Dwelling type:	House and Garage.
Dwelling configuration:	Single Storey.
Nature of works:	New Building.
Stage of inspection:	Pre Plaster.
Construction Type:	Multiple Claddings.
Garage:	Attached.
Foundations:	Slab.
Builder:

Client Brief

Schedule of Defects:

Defects, observations and other related comments from the Slab and Frame Inspection on the 13/04/2021:

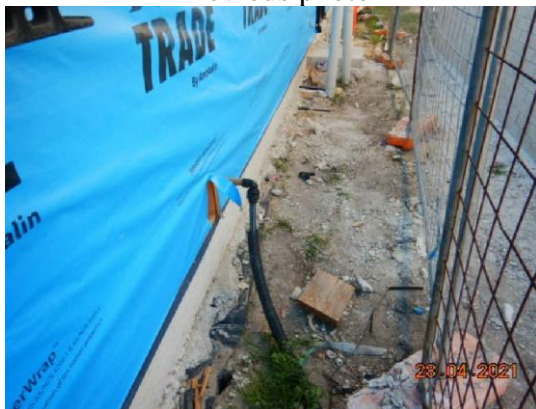
NCC, 2019; 3.1.3.3: - The external finished surface surrounding the slab must be drained and graded to give a slope of not less than 50mm over the first 1 metre.
(25mm in areas of *low rainfall intensity areas*)

Surface water drainage on this site has not met the performance requirements of the National Construction Code.

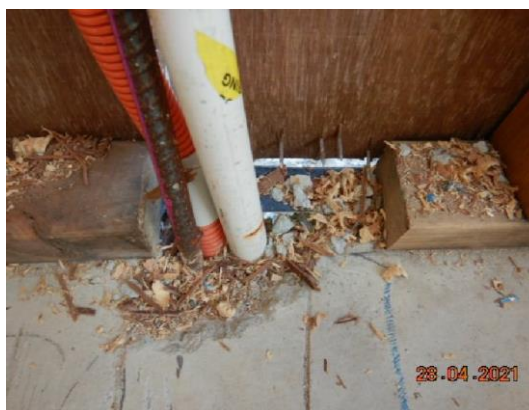
AS 1684.2; Table 8.18: - The sheet bracing shall be installed using 30 x 2.8 mm diameter galvanised flat head nails at the required spacings given in the table below. Many of the nails have been over driven or overshot below the surface of the bracing ply. Overshot nails have compromised the bracing sheet's ability to resist racking forces. Also note the minimum sheet thicknesses given below.

Bracing panels with overshot nails have not met these requirements.

All sheets to be checked

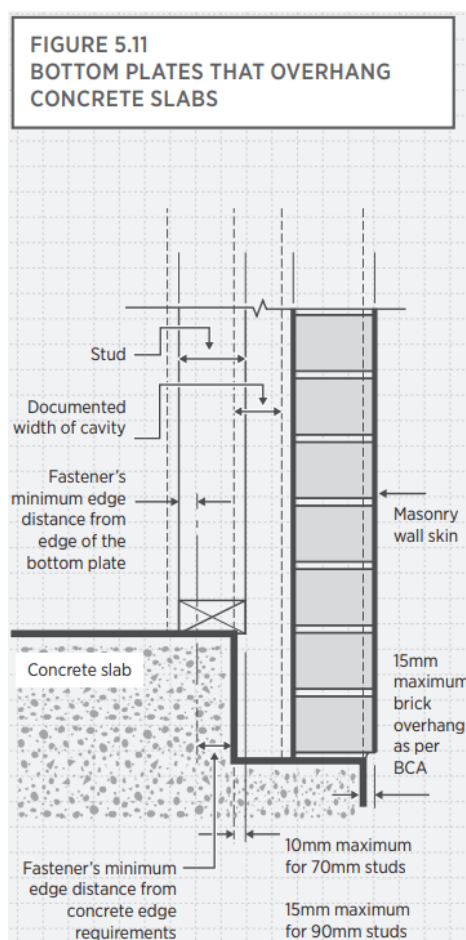
AS 1684.2; Appendix J2: - Mechanically laminated members utilising EWP's (Engineered Wood Products) such as LVL's should be undertaken in accordance with the manufacturer's specifications.

LVL laminations are presenting with sizeable gaps, and as such, have not met these requirements.

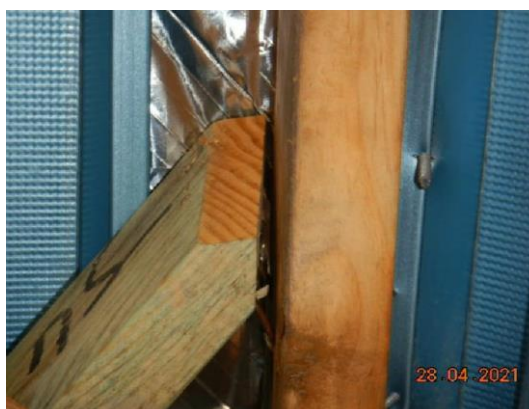
AS 4440; Fig 5.2: - Creeper rafters and jack trusses up to 1800 mm shall be fixed to the hip with 3/65mm nails (minimum).

This requirement has not been met.

Only one nail

Nails bending over, not fully nailed

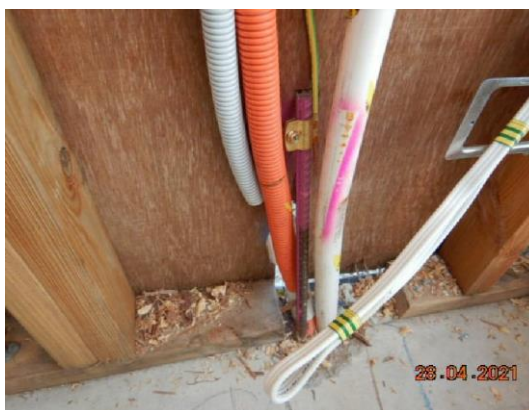
The rusting steel rod to the earthing on the slab is connected to the steel inside the slab.

As such it must be a treated material such as a galvanised rod or the like. The current installation will continue to rust and will allow the transference of rust.

The builder needs to treat the rod to remove all rust and then paint same one the earthing strap has been applied. Please note it must be painted after the earthing strap has been installed.

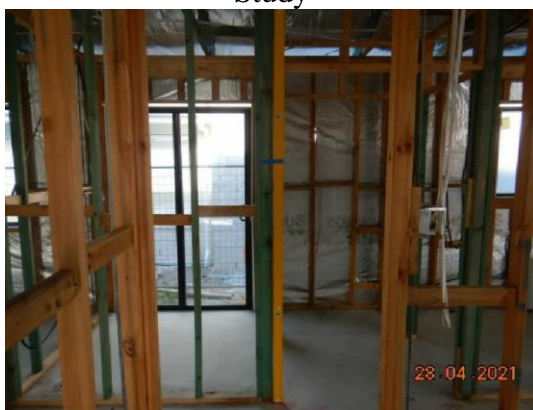
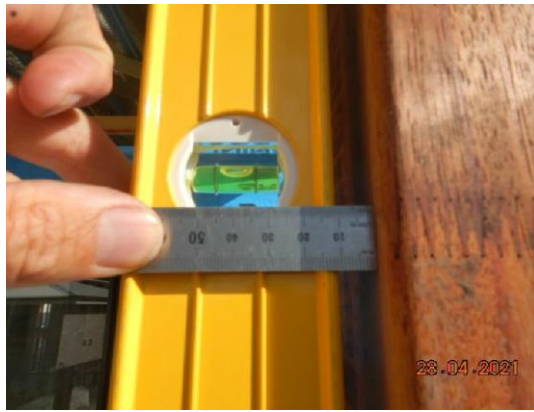
QBCC Standards and Tolerances Guide: - Timber wall frames and exposed posts are defective if they deviate from vertical by more than 4 mm within any 2-metre height.

Walls frames and/or exposed posts to this dwelling have not met this requirement.

Note: walls along the right side of dwelling are out, not all marked up.

Study

Hall

Laundry

Bed 1

Kitchen

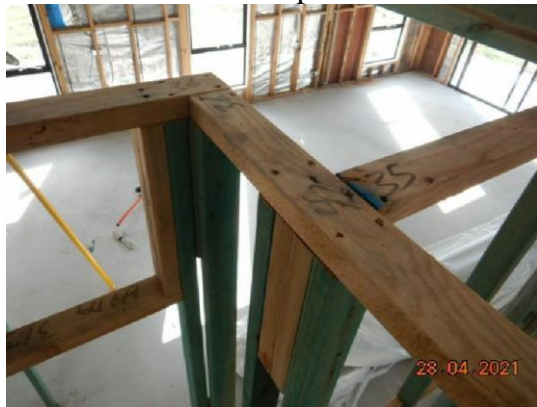
AS 1684.2; 9.2.8: - calls for the installation of a plate connector (gang nail plate or equiv.) at the top of all intersecting walls. Where plates interlock, they are not required.

There are gang nails missing to several of the top plates to the wall's connections. These plates play a vital role in securing one wall to another. It also assists with the racking force resistance on a home.

In areas, top plate connections have not met this requirement.

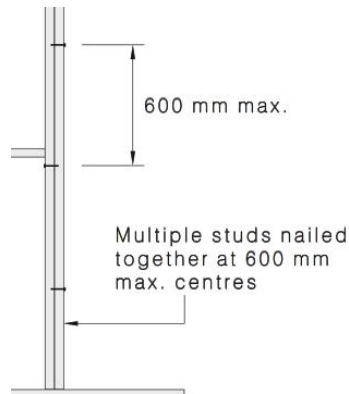
AS 1684.2; 2.4: - Multiple studs at sides of openings or in locations supporting concentrated loads shall be laminated together as follows.

Nail spacings exceed 600 mm.

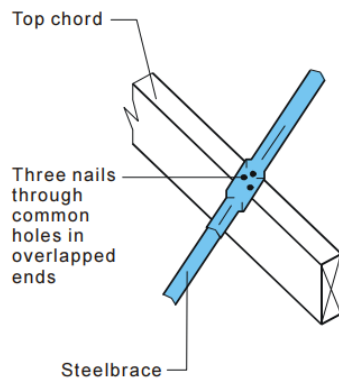
AS 4440; clause 4.3.8(a): - Diagonal steel roof braces (speed brace) shall be splice fixed to the top chord in accordance with one of the following methods.

The roof frame has not met this requirement.

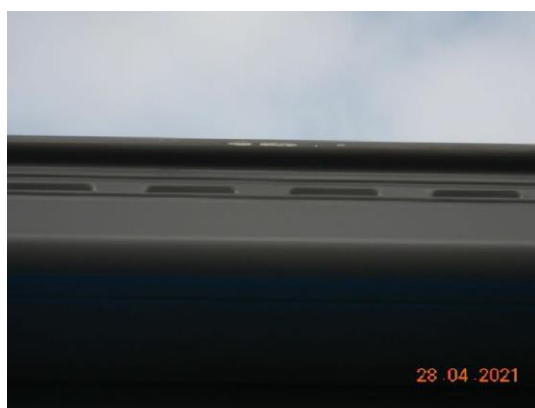
The BlueScope Colorbond roofing products to the dwelling have been damaged during construction.

BlueScope Technical Bulletin-38: - BlueScope do not support the use of touch-up paints on 'Colorbond' steel, and that their use will invalidate the BlueScope Warranty.

Damaged areas greater than 2mm in width will need to be replaced.

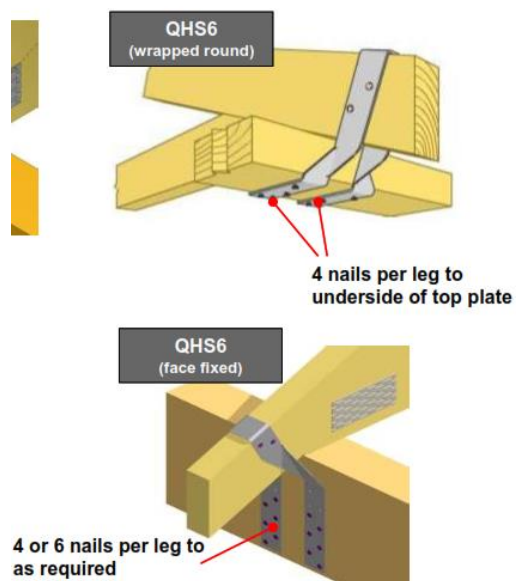
AS 1684.2; Table 9.21(e) & Pryda installation guide: - Cyclone straps shall be installed in accordance with the following table.

Further fixings are required to meet the minimum standard.

Strap has been pulled off and now there is only 3 nails holding

4 nails into LVL's and 6 nails into MGP10 MGP12.

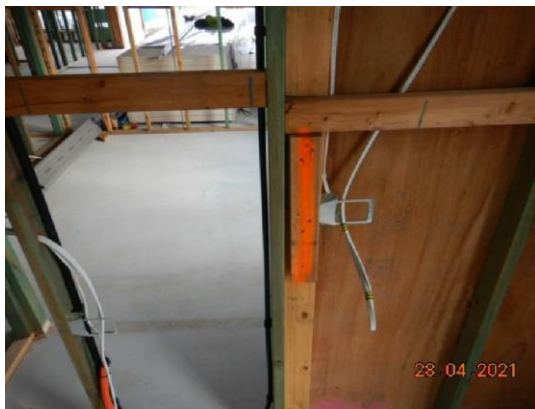
The deviation in the position of the bearing surface of the finished framing immediately prior to installation of lining from a 1.8 m straight edge shall not exceed the values given in Table 4.2.2 when measured over a 1.8 m span at any point [see Figure 4.2.2(A)].

Where the dimensional tolerances of the fixing surface plane fall outside these tolerances, a suitable levelling system shall be used [see Figure 4.2.2(B)].
